South Texas Project Electric Generating Station P.O. Box 289 Wadsworth, Texas 77483

September 29, 1998  
NOC-AE-0231  
File No.: G20.02.01  
G21.02.01  
10CFR50.90

South Texas Project  
Units 1 and 2  
Docket Nos. STN 50-498 and STN 50-499  
Proposed License Amendment Associated with Revised Calculation Methodology  
for Loss Of Coolant Accident Mass and Energy Release Analysis

**FIGURE 6.2A.1.1-37**  
**CONTAINMENT TEMPERATURES**  
**Double-Ended Pump Suction Guillotine Break**  
**Maximum SI, Minimum CHRS**  
**(DELTA-94 Steam Generator)**

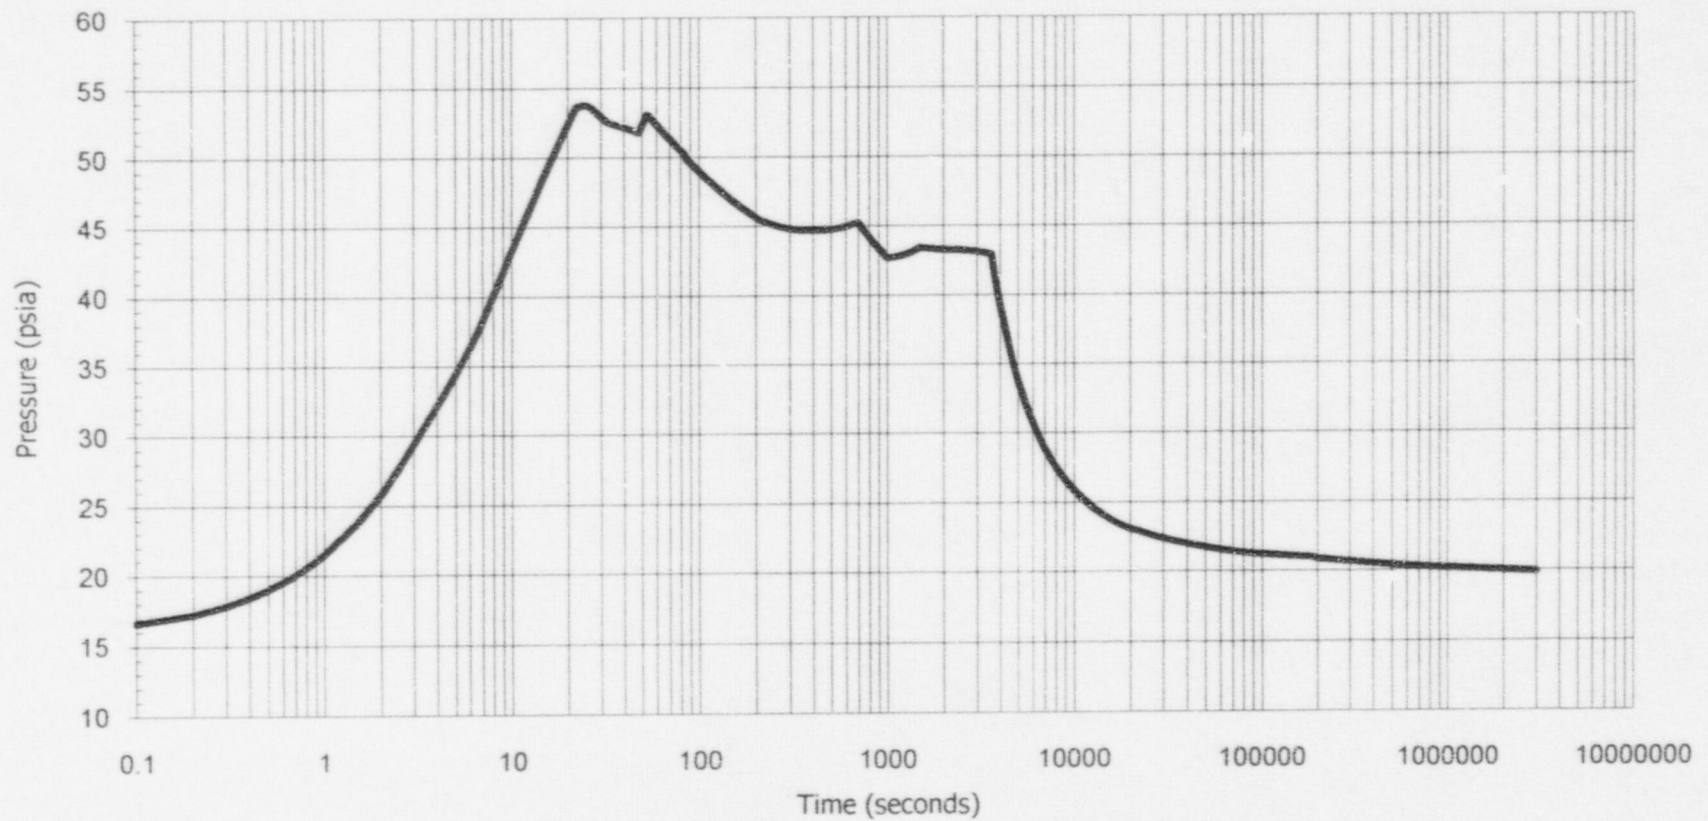
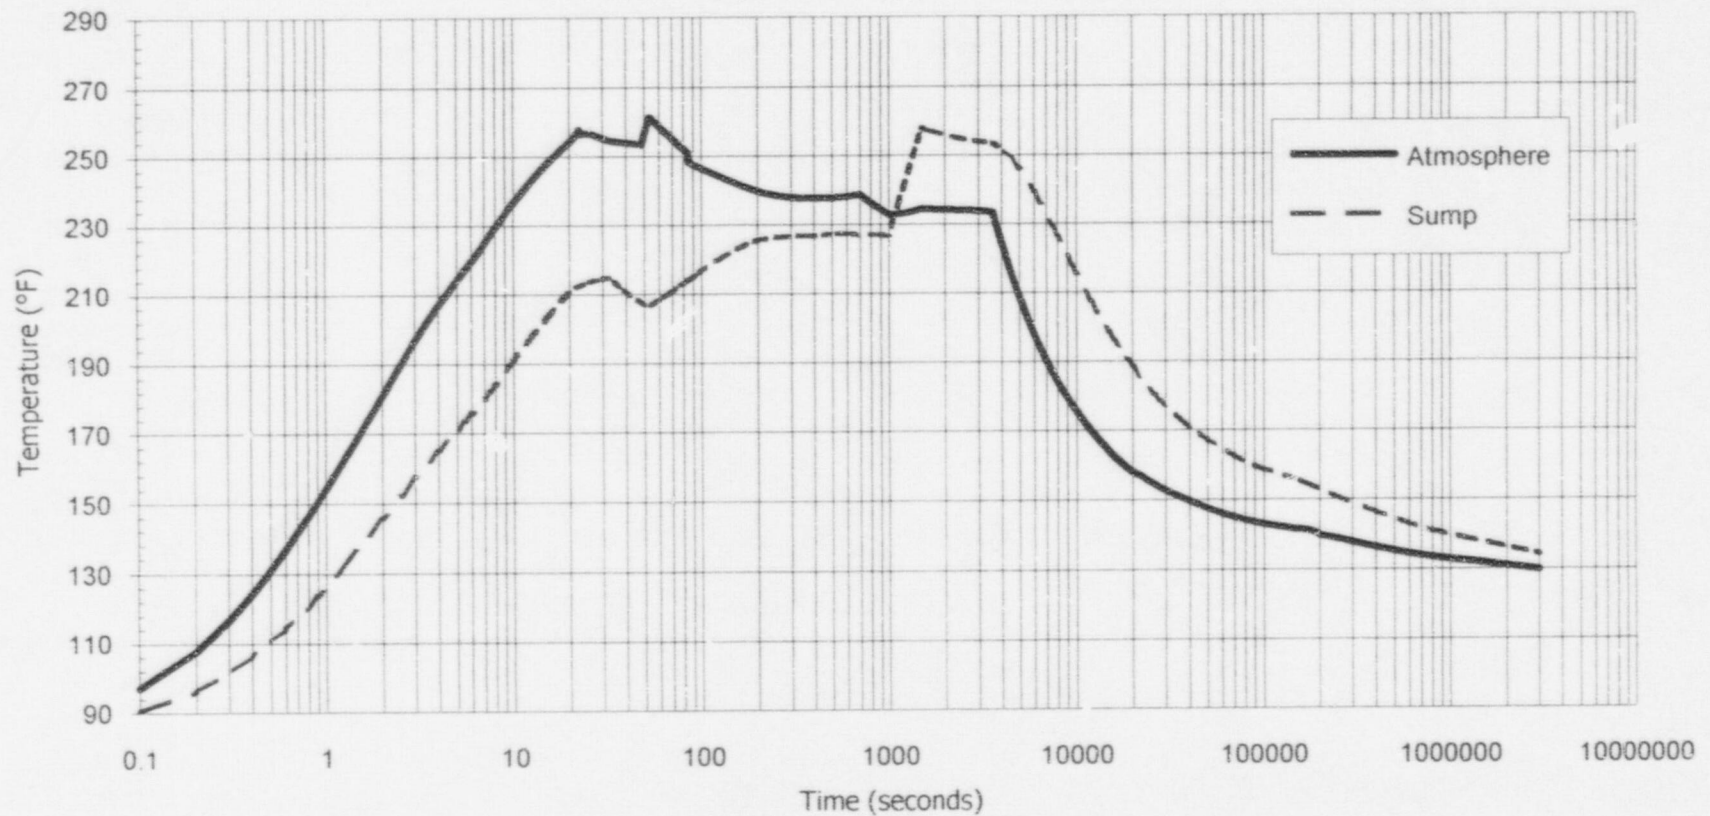
Containment pressure and temperature analyses results for  $\Delta 94$  steam generators are provided in attached UFSAR markups:

- Table 6.2A.1.1-4, summary of design basis LOCA containment pressures and temperatures.
- Figures 6.2A.1.1-30 to --38, pressure, temperature, and heat transfer coefficient profiles,

Figures 6.2A.1.1-30 through -38 provide plots of various Containment thermodynamic parameters as a function of time for the analyzed DEHL and DEPSG breaks.
